ADDENDUM NO. 3
BID FORM

OLIVEHURST PUBLIC UTILITY DISTRICT
OLIVEHURST, CA

Project Name: Contract No. 2: Pump Stations and Pipelines
CWSRF Project No. C-06-8753-110

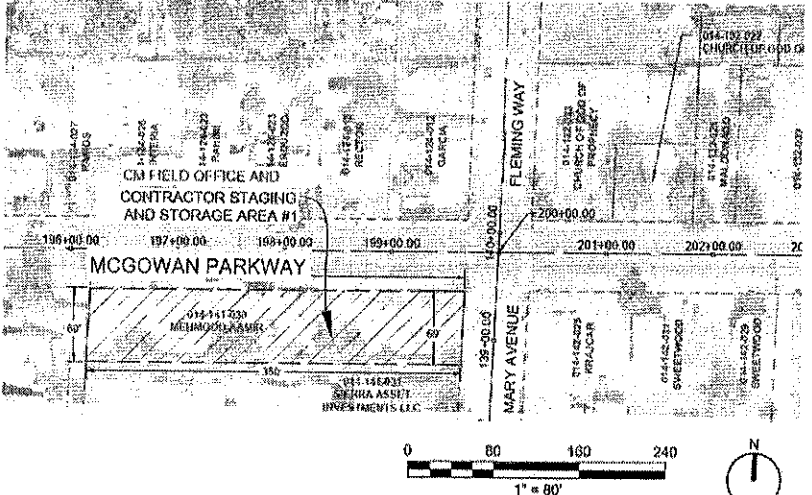
Item	Part/Section	Description of Change																																			
		timing will also need to be approved by Owner. Between the outage periods, the Contractor shall operate a temporary collection system that allows for constant flow 24 hours per day 7 days a week. The temporary collection system shall be approved by OPUD and Engineer prior to implementation. Use of tanks (truck mounted or otherwise) will be acceptable options for holding sewage during the interruptions, and disposal of those tanks at the OPUD WWTP (or in nearby sewer manholes) can be completed at no additional cost to the Contractor for disposal.																																			
11	Volume 2 Section 02 40 00 Tunneler Crossings 3.03.A.3	3.03.A.3: Delete Geotechnical Data Report (GDR): October 2025, prepared by Blackburn Consulting entitled "Geotechnical Data Report – Revision 1" and Replace with attached Geotechnical Data Report (GDR), Revision 2, dated January 2026.																																			
12	Volume 3 Section 31 79 31 Pipe Ramming 3.01.A.4	3.01.1.4: Delete item 4 in its entirety and renumber remaining paragraphs.																																			
13	Volume 4 Sheet G-8	Replace Detail Callout for Staging and Storage Area #7 from G to H.																																			
14	Volume 4 Drawing Sheet 73	Table A—Surface Conditions. Delete Final Backfill Type B4 as shown below since there is no B4 backfill

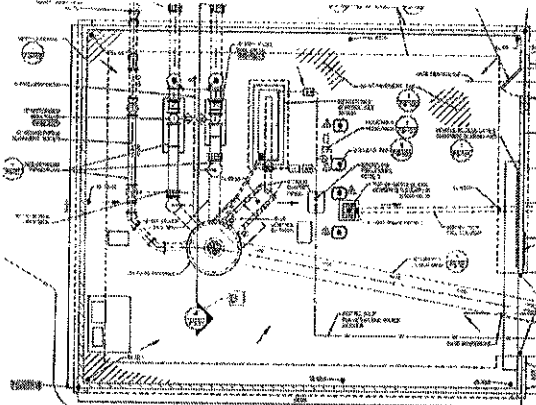
Item	Part/Section	Description of Change																																																																																										
27	Volume 4 Drawing PS-30	<p>On Sheet PS-30, change the Callout labelled as A/PS-31 to B/PS-31</p> 																																																																																										
28	Volume 4, Drawing PS-107	<p>Add the following as Note 2.</p> <p>The biobed media shall be a mix of 60% 3/8" pea gravel and 40% medium to large, hardwood woodchips.</p>																																																																																										
29	Volume 4 Drawings	<p>Delete the following Drawings in their entirety and Replace with attached Updated Drawings</p>
